MEMORANDUM

SUBJECT: Item No. 3.9 - DA2023/1461 - 13 Amiens Road CLONTARF

The purpose of this supplementary memo is to advise the Panel that the applicant has provided additional details regarding the proposed inclinator to be constructed between the detached garage and dwelling house adjacent to the southern side boundary.

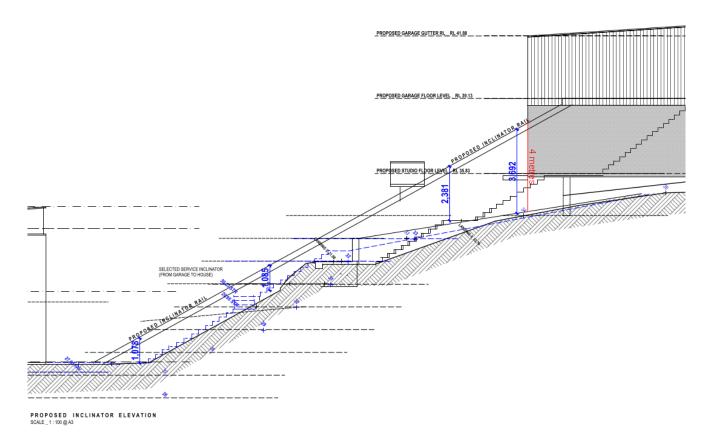
Since the publishing of the DDP agenda, the applicant has submitted a revised inclinator plan that details the height of the inclinator rail relative to the existing ground level.

The overall length of the inclinator is approx. 21m between the rear of the proposed detached garage and the front terrace of the dwelling house. The maximum height of the inclinator rail is approx. 4m at the detached garage and descends to approx. 1.1m above the existing ground level at the midpoint and maintains this height to the base. Refer to the figure below for details.

The inclinator rail is setback 0.6m and the inclinator car is setback 0.3m from the southern side boundary. Due to this setback, visual privacy impacts upon the adjacent property may occur. The landscape plan indicates screen planting is proposed along the southern boundary to assist in reducing privacy impacts. However, vegetation along is not considered sufficient to mitigate the privacy impact of the inclinator. As such, a condition requiring a 1.7m high privacy screen along the southern side of the inclinator car is recommended.

Additionally, a condition is recommended to mitigate acoustic impact of the inclinator motor by requiring that the motor not produce noise levels that exceed 5dBA above the background noise when measured from the nearest property boundary.

Inclinator Privacy Screen

A 1.7 metre high privacy screen is to be along the southern side of the inclinator car. The privacy screen shall be of frosted glazing, fixed panels or louvre style construction (with a maximum spacing of 20mm), in materials that complement the design of the approved development.

Inclinator Motor Noise

The inclinator motor shall not produce noise levels that exceed 5dBA above the background noise when measured from the nearest property boundary.
